NOTICE TO THE PARTIES IN: NUCLEAR INNOVATION NORTH AMERICA, LLC
(SOUTH TEXAS PROJECT, UNITS 3 AND 4)

SUBJECT: RECEIPT OF COMMUNICATION REGARDING
SOUTH TEXAS COMBINED LICENSE
APPLICATION

Technical Concerns Regarding the Uncontested Hearing for Issuance of Combined Licenses for the South Texas Project Units 3 and 4, SECY 15-0123

Prepared by **Hosung Ahn**, Hydrologist, NRO/DSEA/RHMB, November 2, 2015

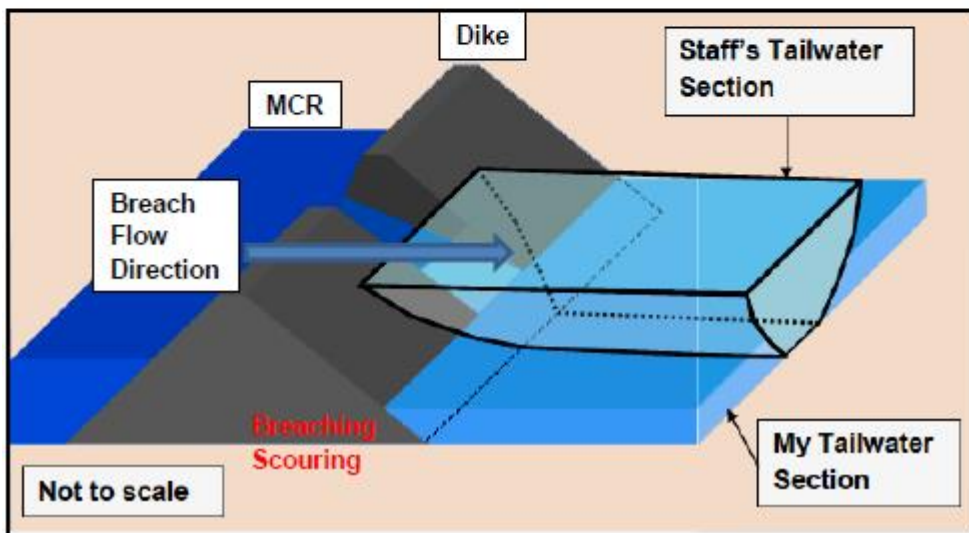
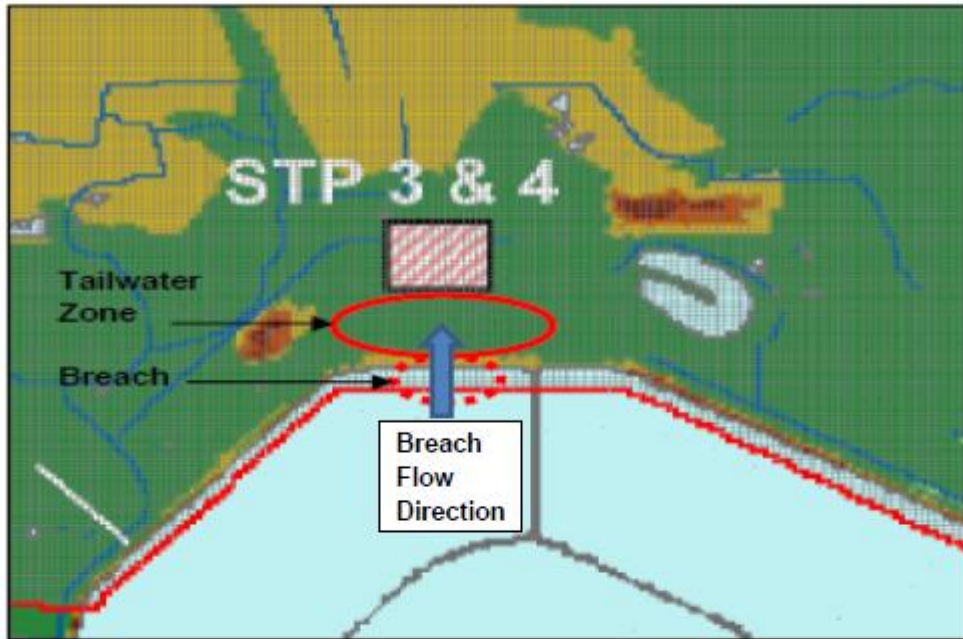
My re-analysis revealed that both licensee's and staff's above conclusions are inaccurate. Their sensitivity analyses were based on a fictitiously-drawn small tailwater cross section above the land surface (see Figure 1 (bottom)). This results in artificial constriction of the breach process in the model. That is, the fictitious tailwater channel induces a small breach head (i.e., the water level difference between MCR and tailwater section) by inadvertently increasing tailwater level during the early stage of a piping failure.

The actual breach tailwater zone is a wide and flat open area (over 0.8 miles as shown in Figure 1 (top)). However, the tailwater cross sections specified in the licensee's and staff's BREACH models were small enough (bottom width of 600 ft) to constrict a full breach growth. This is a rudimentary modeling error. All three external peer reviewers failed to recognize this issue and/or misinterpreted the BREACH modeling and result presented in the re-analysis report.

- If the two issues discussed here, foundation scouring and tailwater section, were considered correctly, the licensee's design flood level would be 2.4 ft higher than their estimate even with the licensee's n-value of 0.05.
- My re-analysis indicates that a reasonable site design basis flood level should be approximately 45 ft msl or 5 ft higher than the licensee's estimate if all five issues discussed in the non-concurrence are considered correctly.
- Alternatively, applying a very conservative breach width scenario could result in a design basis flood level of 47 ft msl or 7 ft higher than the licensee's estimate.

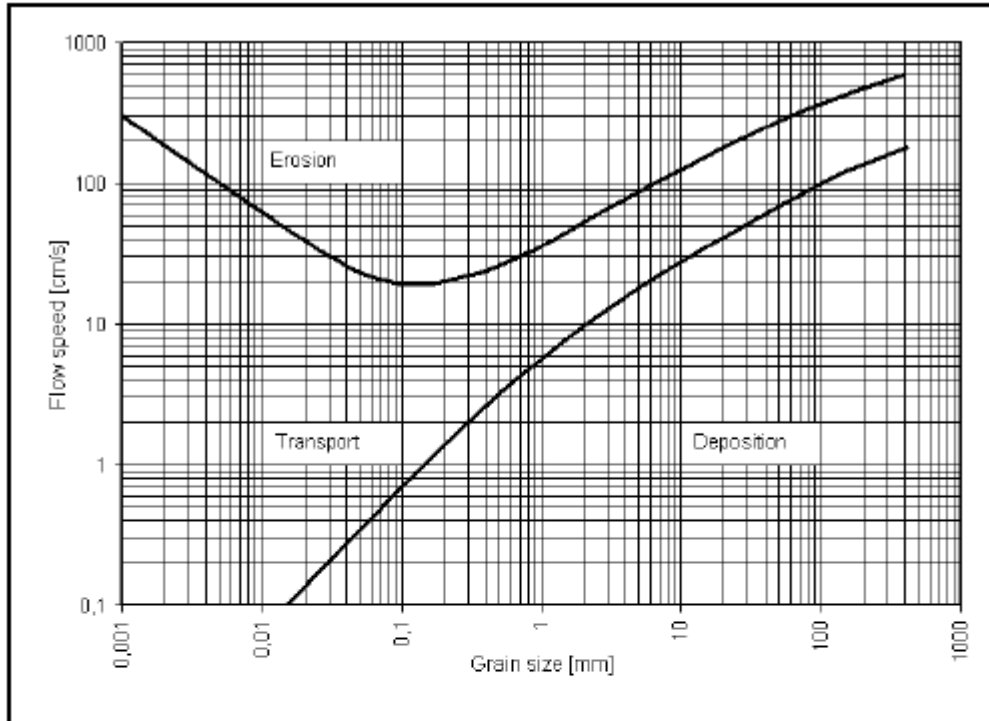
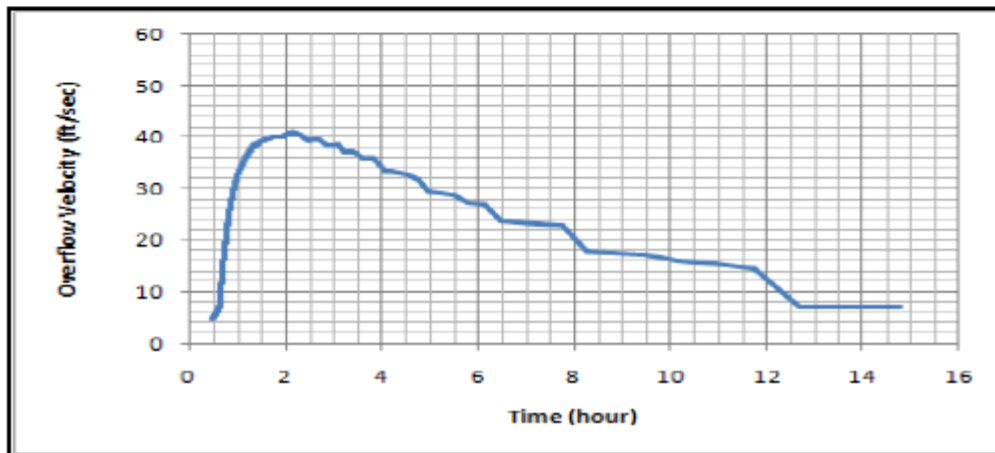
The result of the MCR BREACH runs indicates that the breach flow velocities range from 10 feet per second (ft/s) to 40 ft/s (Figure 2 (bottom)). These velocities exceed significantly the critical erosion velocity of 10 ft/s (from the Hjulstrom Curve in Figure 2 (top)) for the given clay soils with a particle size of 0.001 millimeters as specified in the BREACH. The erosion process represented by the Hjulstrom curve developed in 1935 is old but intuitively simple. The theory of the hydrologic erosion process has been advanced substantially during the past 40 years as many accurate erosion equations are now available. The new erosion equation predict the erosion capacity based not only on soil particle size and flow velocity, but also on additional soil parameters such as cohesion coefficient, friction angle, bottom roughness, particle distribution, and critical shear stress coefficients. The Smart Equation adopted in the BREACH model is one of them as it uses both breach flow and soil characteristics.
